**PROJECT NAME: Oyu Tolgoi Underground Project
Rev_1**

REQUEST FOR INFORMATION (RFI)			
TO:	Jacobs	DATE:	06-12-2022
FROM:	MCS International LLC	RFI No:	TWS-0414-RFI-0024
PHONE #:	+976-77226262	REV #	0
SUBJECT: Road train bay 1 & 2: Maintenance pit lifting point and packer's dimension			
Reference Document No.	Rev No.	Title	
1883-55-L4-8768	4	SUPPORT / HOLD DOWN DIAGRAM (DETAILS) INCLUDING LOADS & FORCES	
1883-55-L4-8771	2	ERCTION INSTRUCTIONS	
Discipline Codes (Mandatory)	D1 (CSA) - <input type="checkbox"/>	D2 (MP) - <input checked="" type="checkbox"/>	D3 (E&I) - <input type="checkbox"/> D4 (Other) - <input type="checkbox"/>
<u>Request:</u>			
<p>The Contractor requests the Company to clarify following information.</p> <ol style="list-style-type: none"> 1. The two dimensions of between packer top and TOC (FFL) are different in drawings 1883-55-L4-8768 and 1883-55-L4-8771. Witch dimension is correct. (Attachment 1) 2. In drawing 1883-55-L4-8768, L1 to L8 lifting points locations and WLL are unclear. (Attachment 2)

1883-55-L4-8768

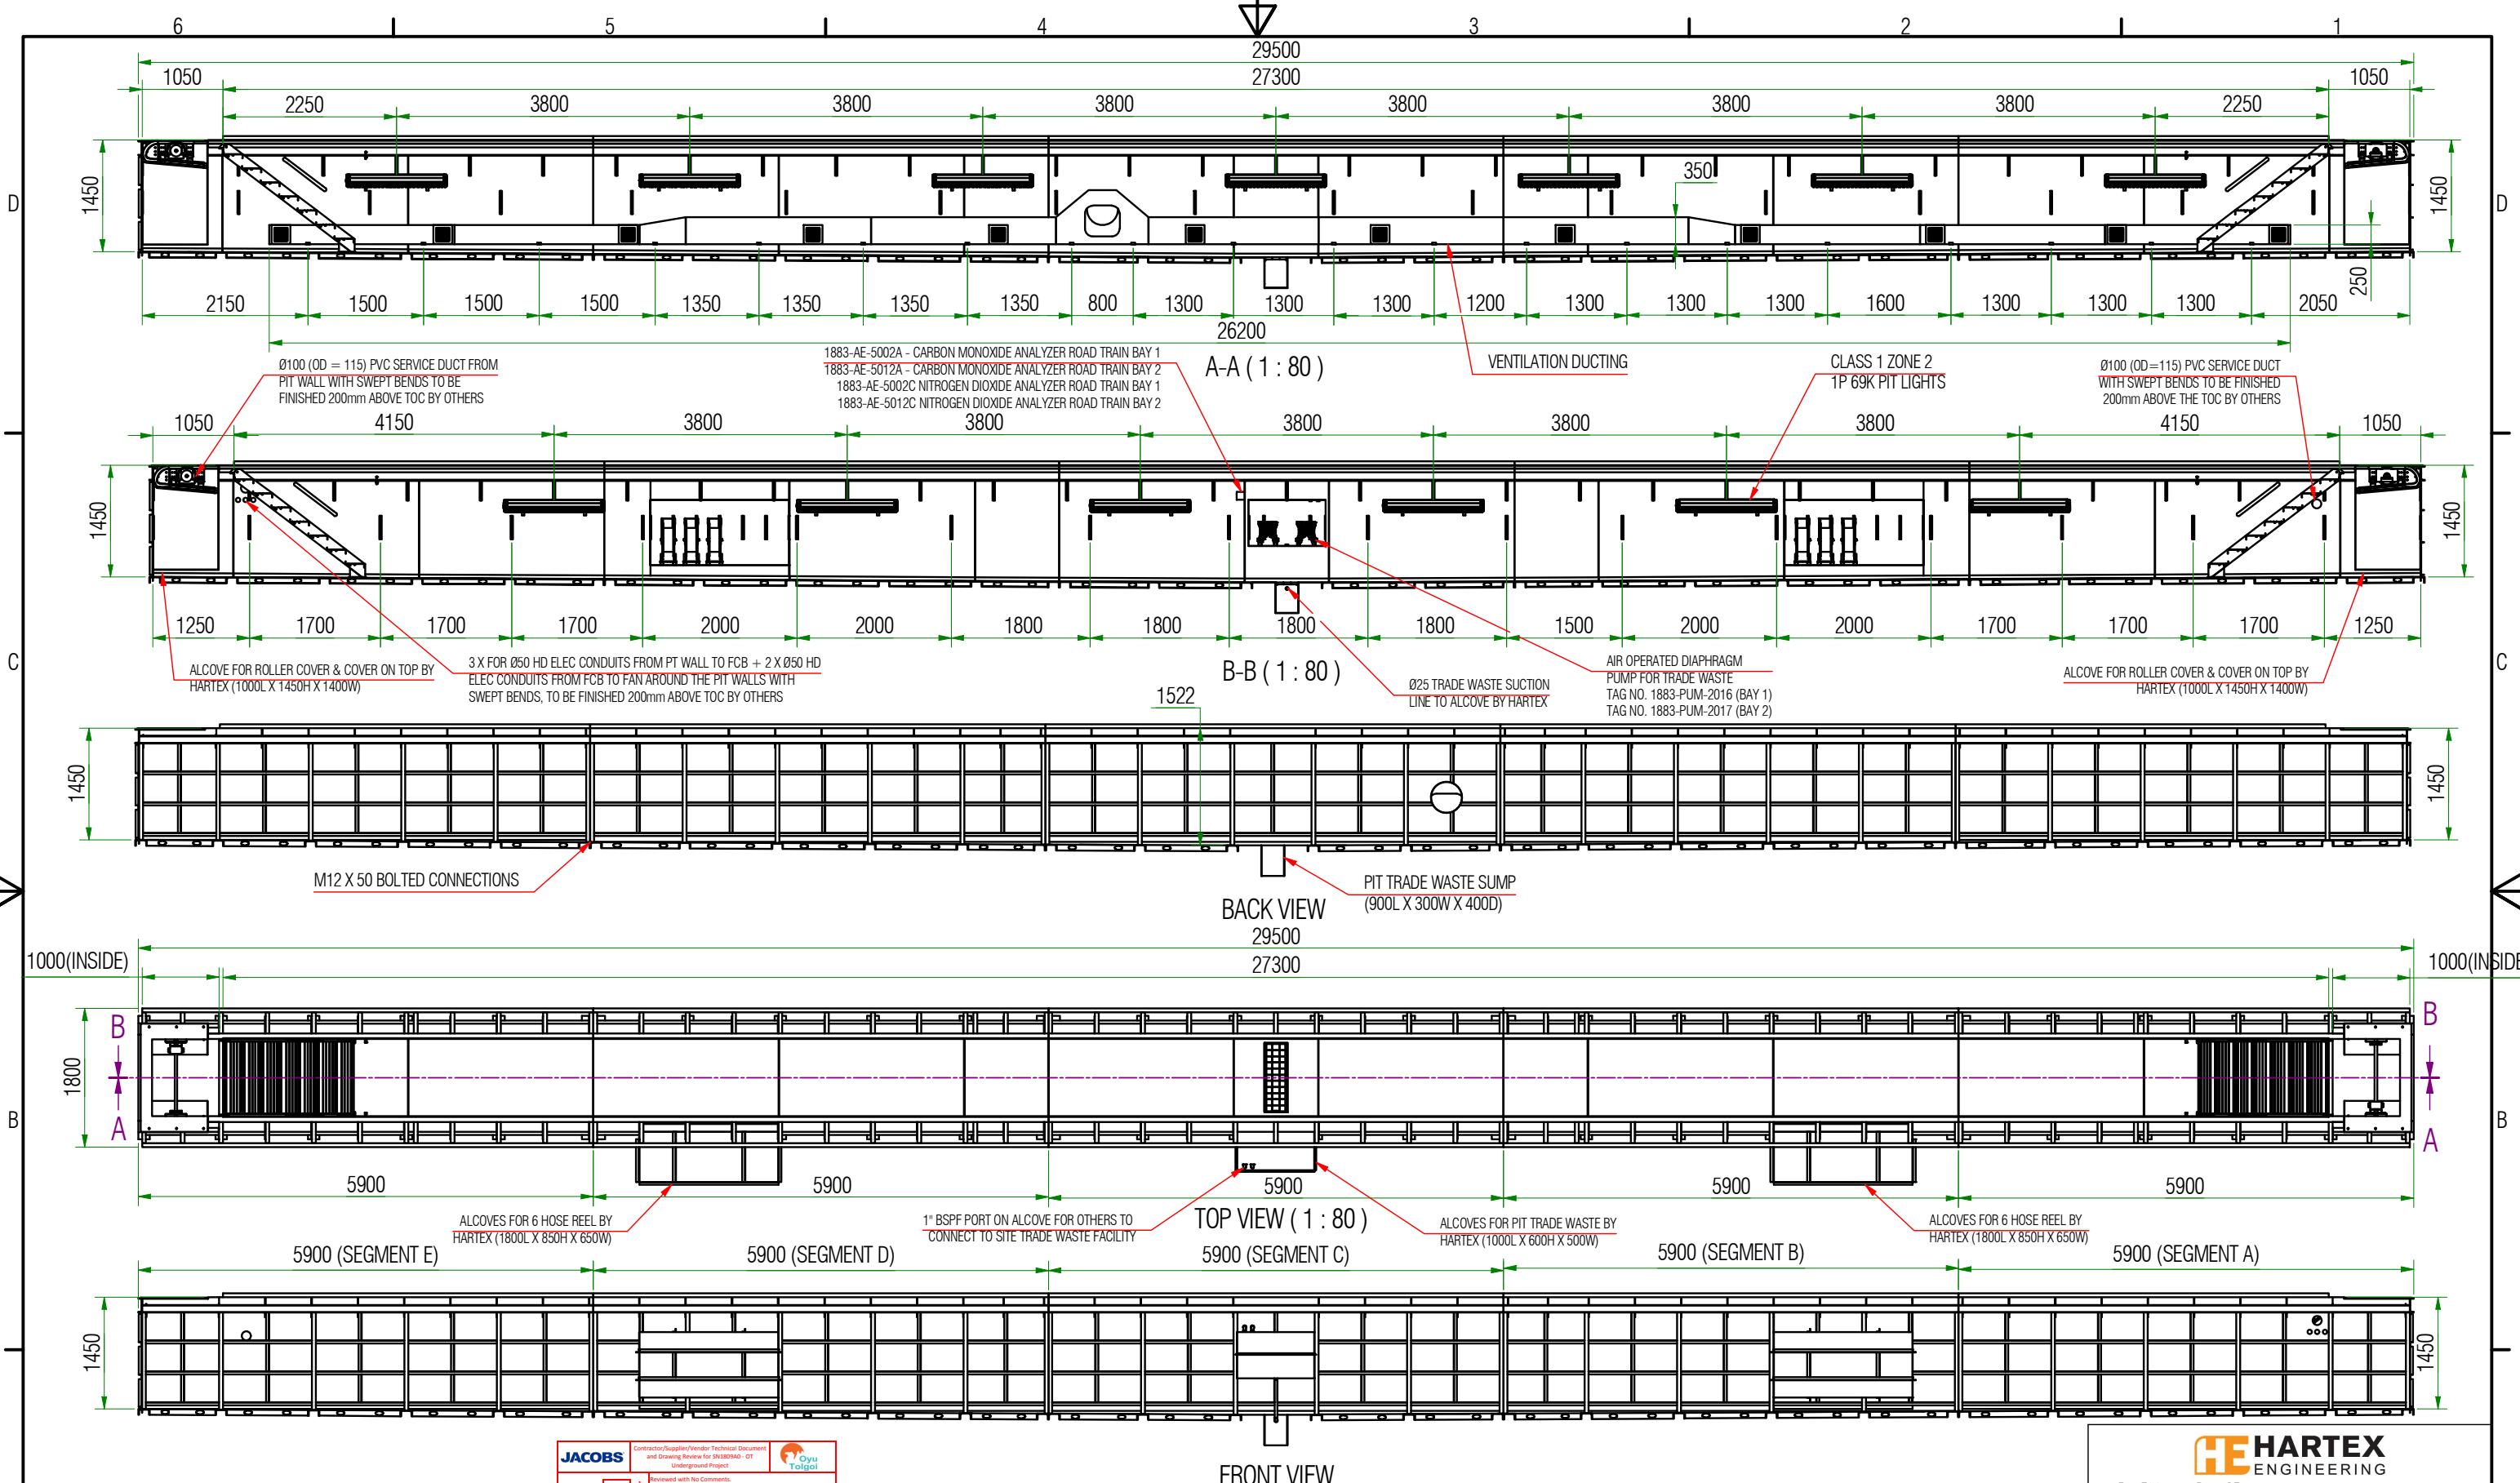
L1 to L8 lifting points locations and WLL are unclear.
